Project No. 2021\_154

MIDLOTHIAN ISD STADIUM ADDITIONS AND RENOVATIONS

ADDENDUM NO. 2

DATE: October 18, 2021

PLAN NORTH TRUE NORTH  
3 UNDERFLOOR PLAN - CONCESSION SOUTHEAST - PLUMBING  
SCALE: 1/8" = 1'-0"

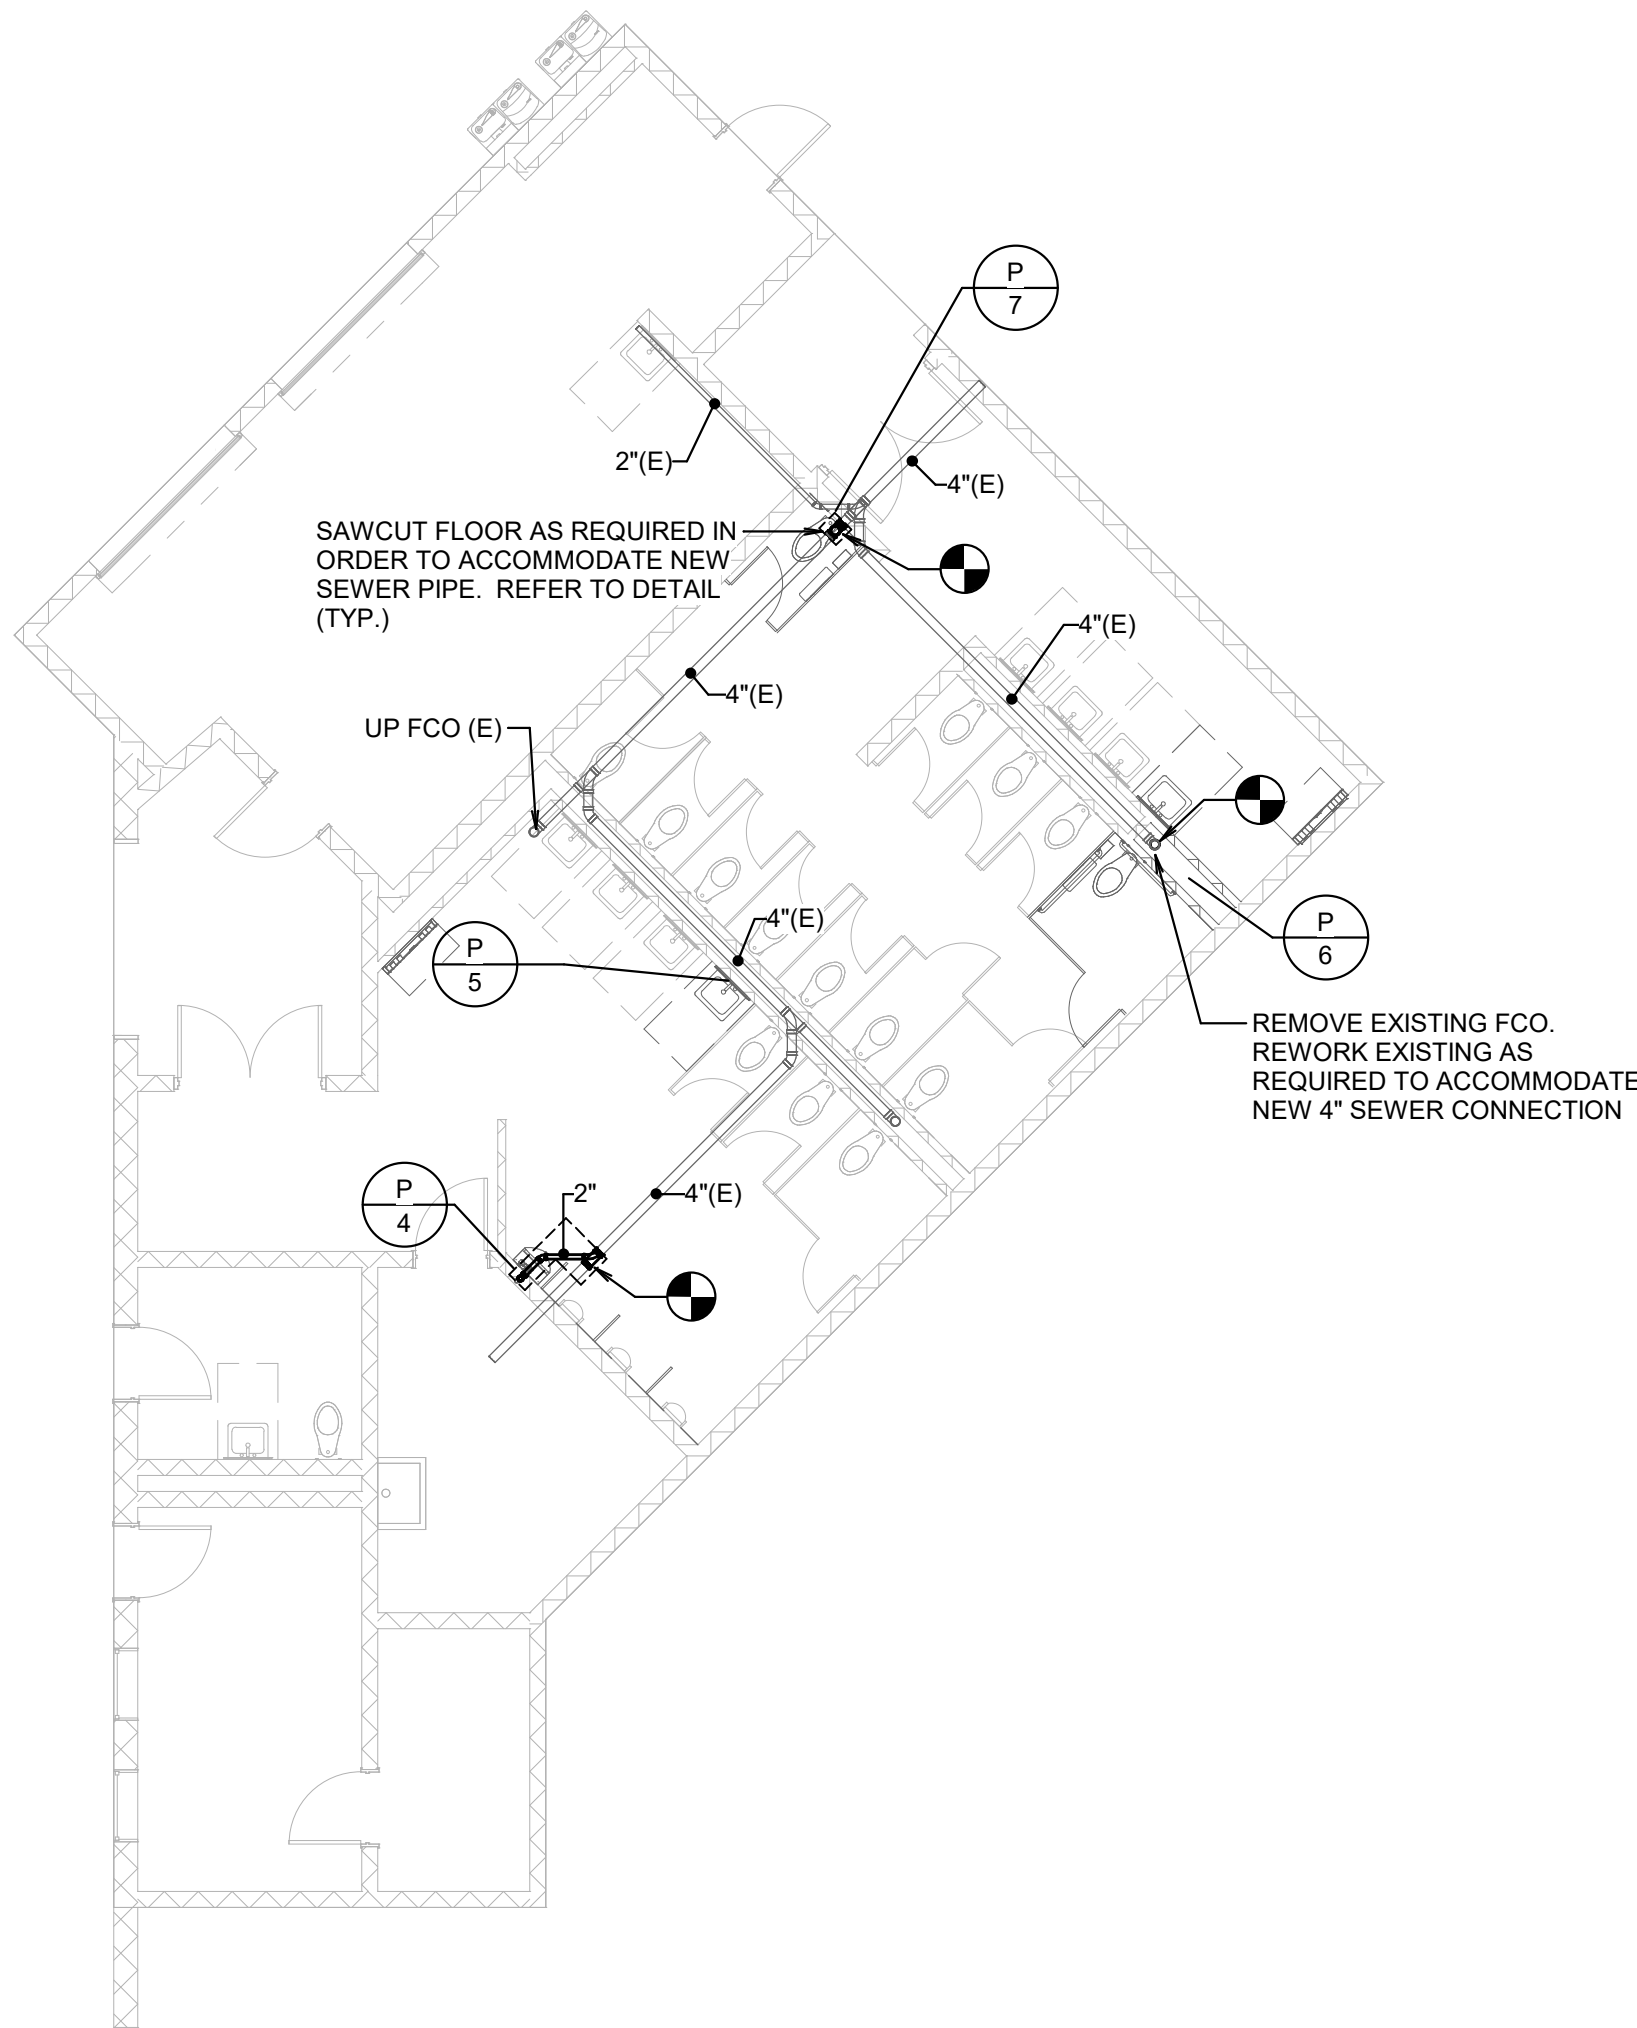
- A2.34 SHEET – P-102 – UNDERFLOOR PLANS – CONCESSIONS - PLUMBING  
ADD in its entirety.  
a. Refer to attached new drawing for ADDED plumbing fixtures at concessions.

FLOOR PLAN - LEVEL 1 - ATHECTIC OFFICE - POWER  
SCALE: 1/8" = 1'-0"

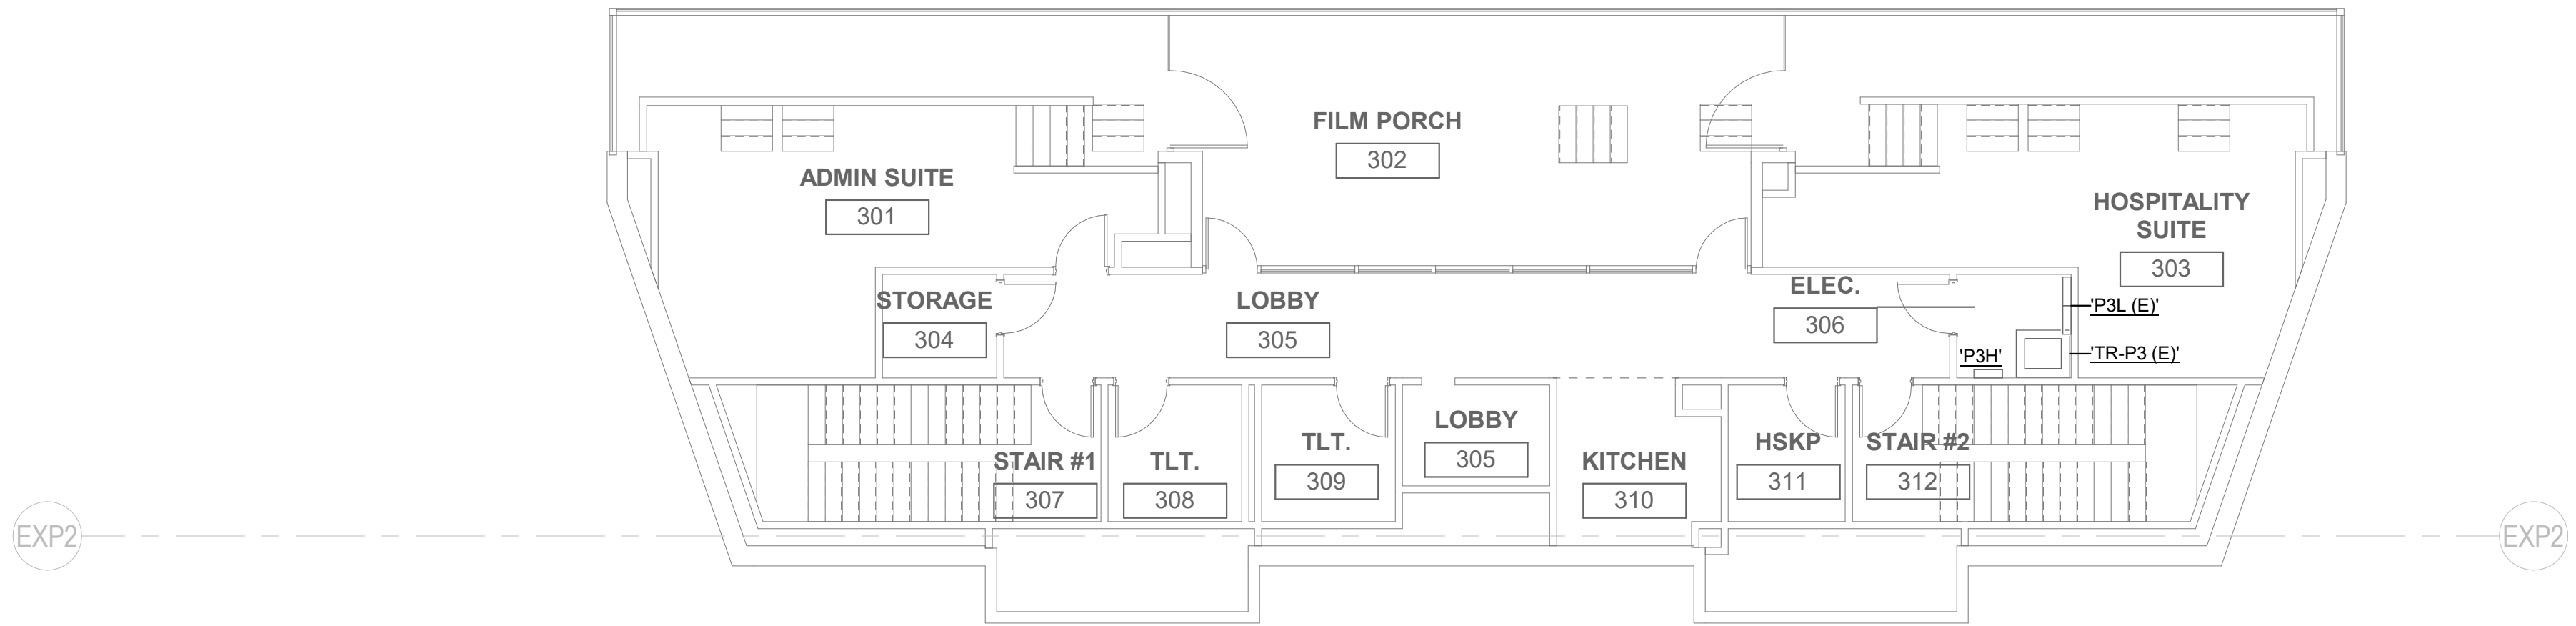
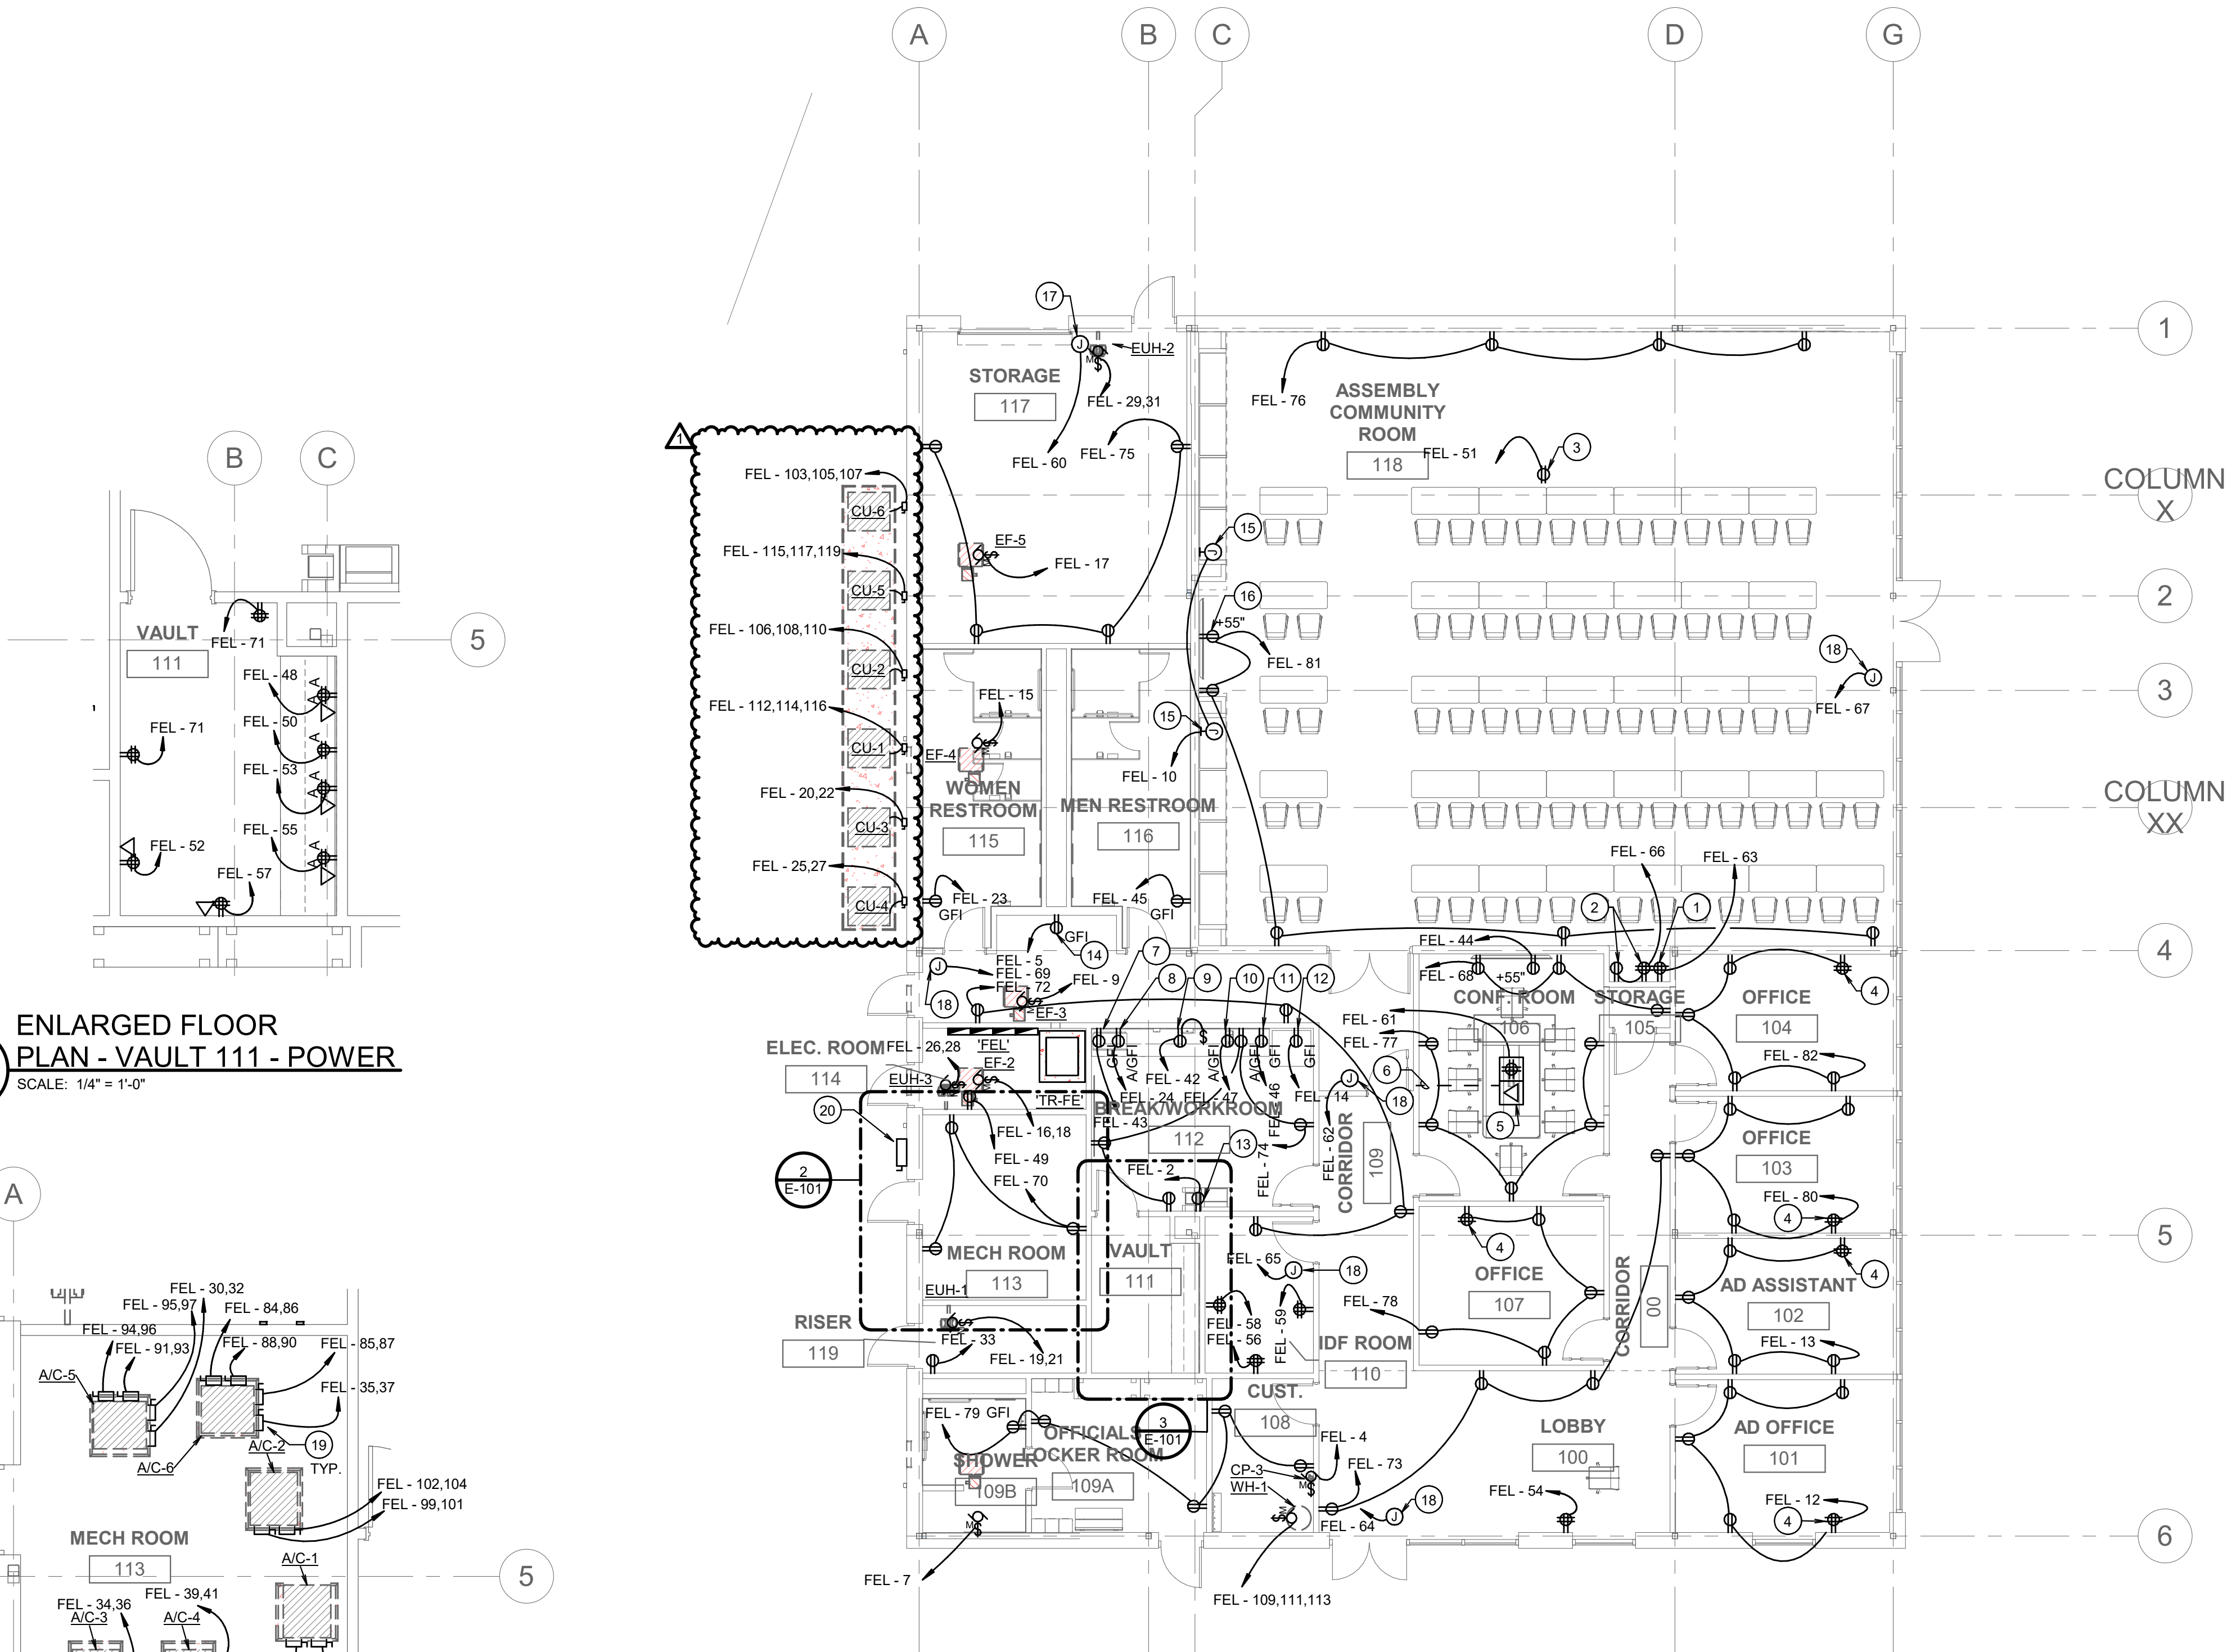
- A2.37 SHEET E-101 – FLOOR PLAN – LEVEL ONE – ATHLETIC OFFICE – POWER:  
REMOVE and REPLACE in its entirety.  
a. Refer to attached drawing for updated locations for disconnects feeding new mechanical equipment.
